FINAL DRAFT MINUTES

February 17, 2022 Standards Committee Meeting

RE: Minutes from the February 17, 2022 Standards Committee Meeting

E 715-BKFL-02 PIPE BACKFILL METHOD 1 NEW ROADWAY, EMBANKMENT (shown markups)

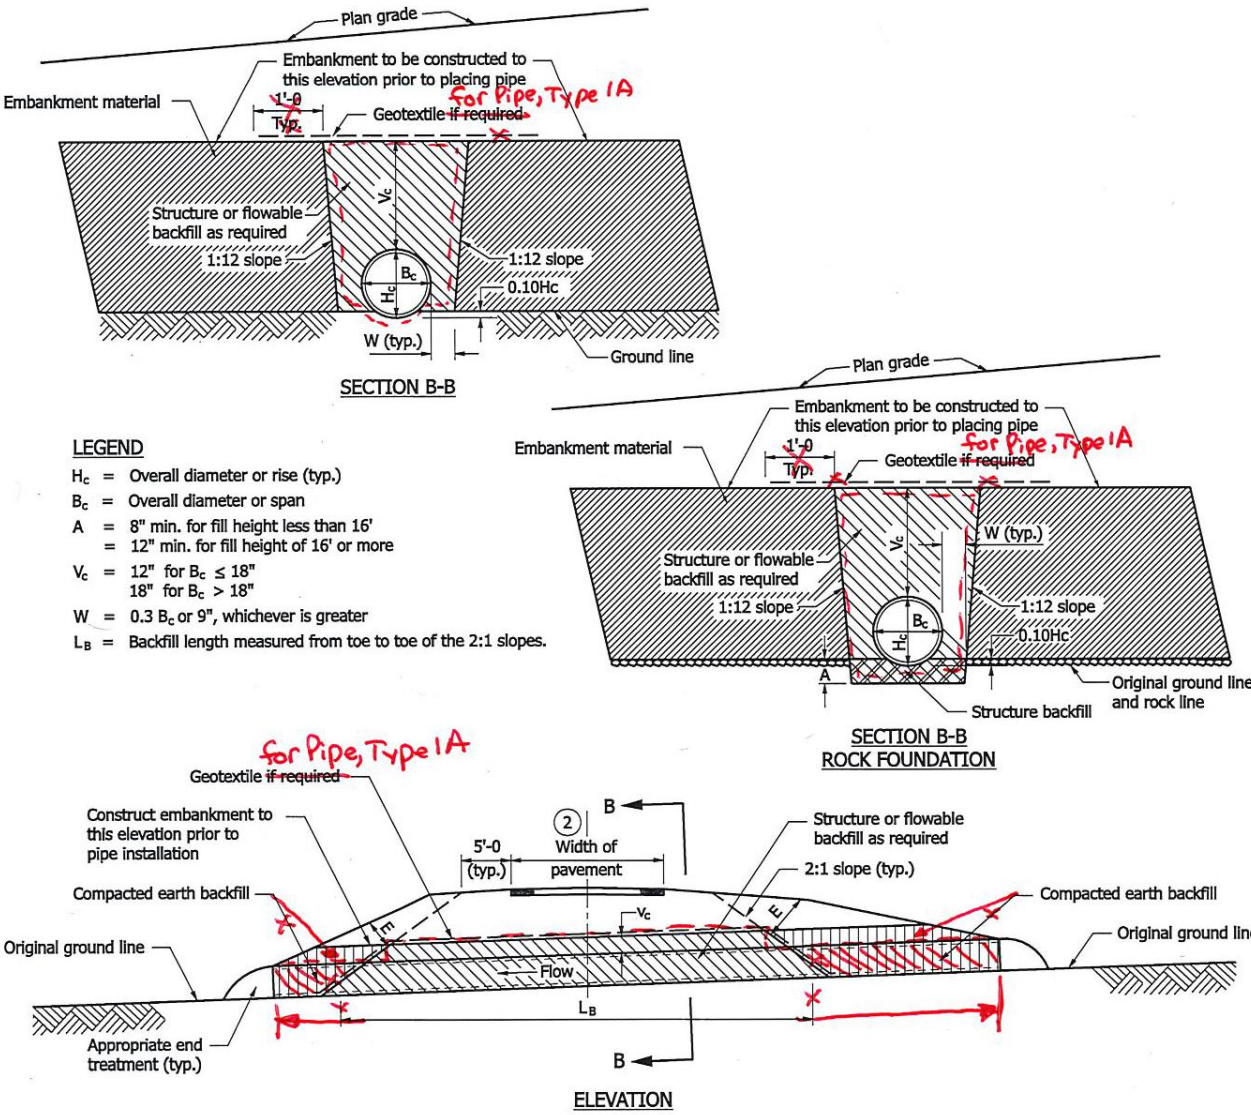
This item was introduced and presented by Mr. Beeson, sitting in for Mr. Reilman, who explained that, currently, the Standard Drawing Series 715-BKFL only shows the geotextile capping structure backfill of pipes to prevent infiltration. Infiltration can occur anywhere around the structure backfill, therefore for, in most locations, structure backfill should be lined and capped.

E 707-BPDF-03 FABRICATION TOLERANCES PRESTRESSED BULB-TEE BEAM (shown markups)

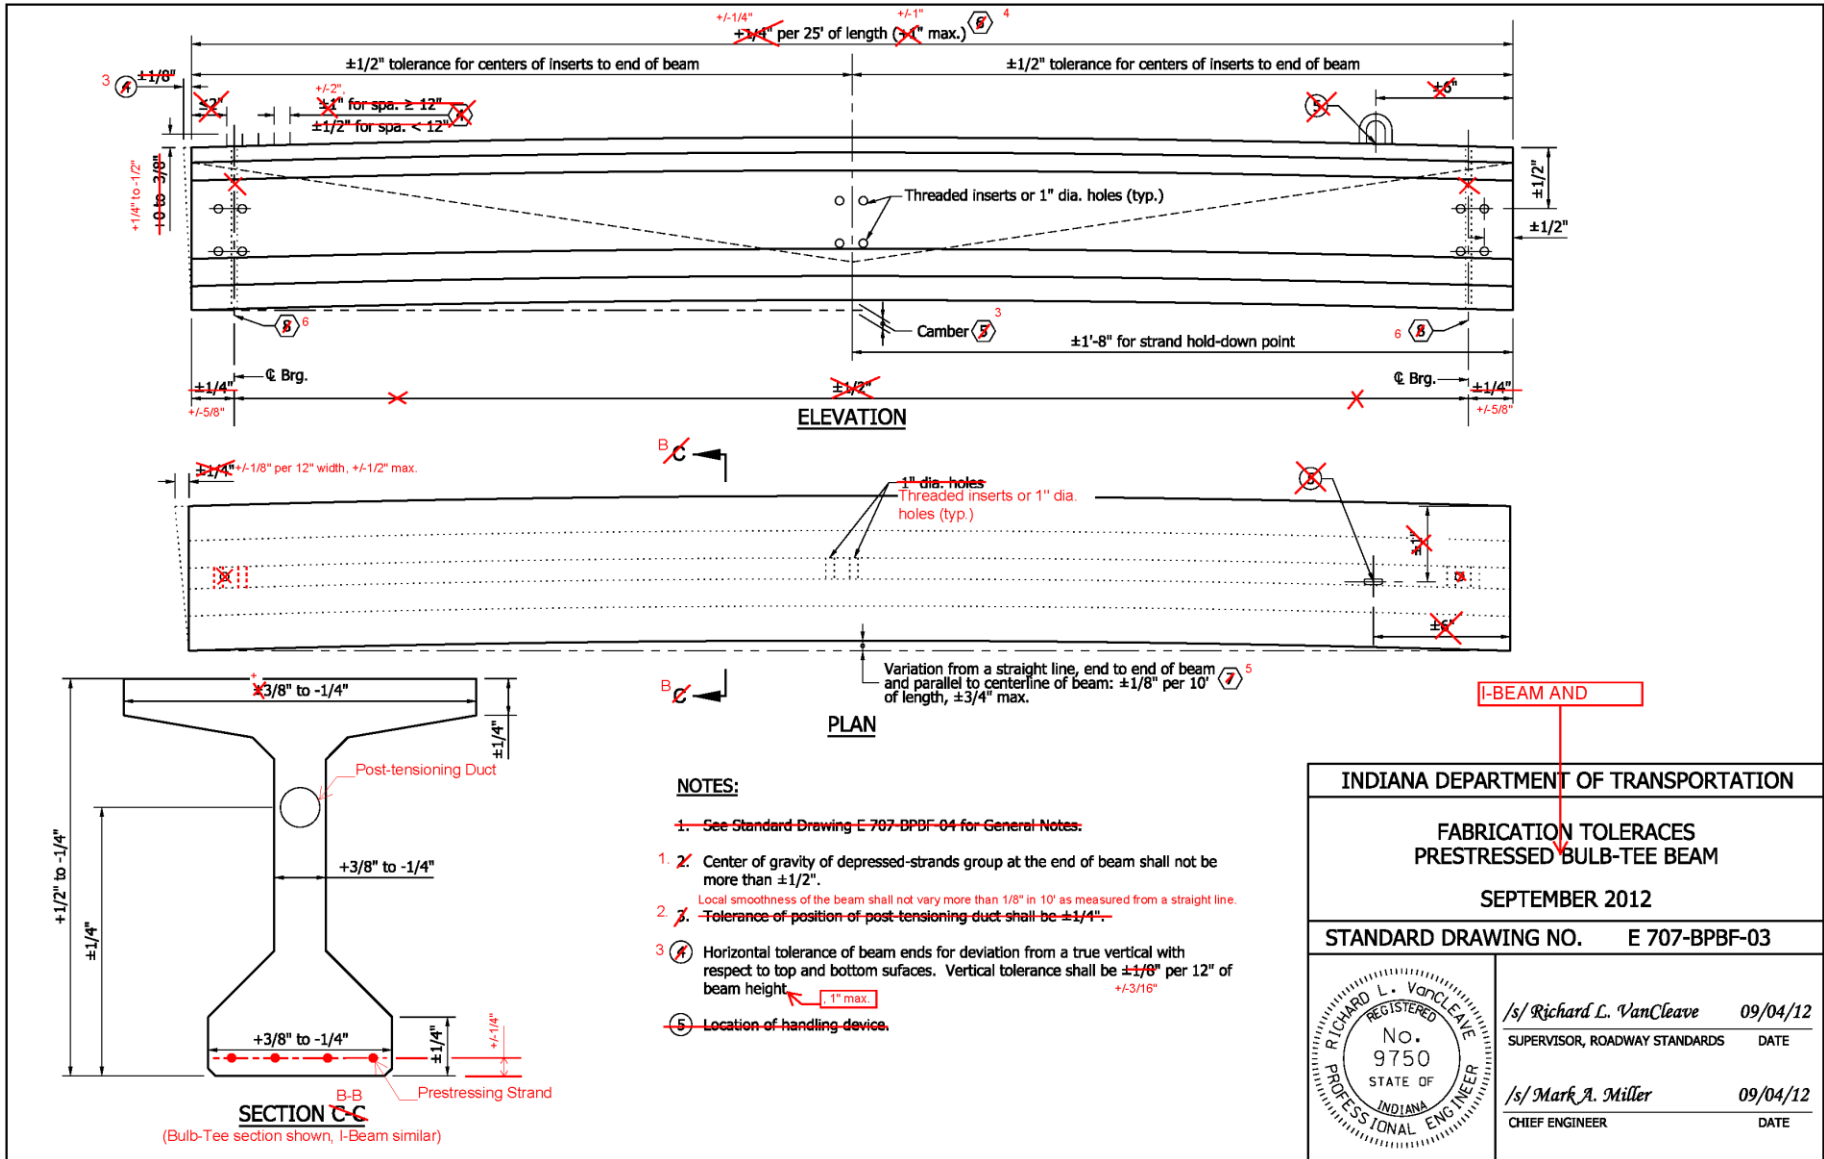
This item was introduced and presented by Mr. White who explained that the E 707-BPBF series Standard Drawings were last published in 2012 and are not in the current format for Standard Drawings. The current sheet 03 shows tolerances for the placement of lifting loops, which are determined by the manufacturer and are not detailed on the design plans. This has caused confusion and delays in the shop drawing review process.

Mr. White stated that several minor changes to the fabrication tolerances are being proposed in order to provide more consistency with the Precast/Prestressed Concrete Institute Tolerance Manual for Precast and Prestressed Concrete Construction, First Edition, Fourth Printing. Since the tolerances for AASHTO I-Beam and Bulb-Tee Beams are the same, current sheets 02 and 03 are being combined into one sheet. The lifting loops that are currently shown on sheet 03 are being removed in order to avoid confusion related to the responsibility of detailing those items.
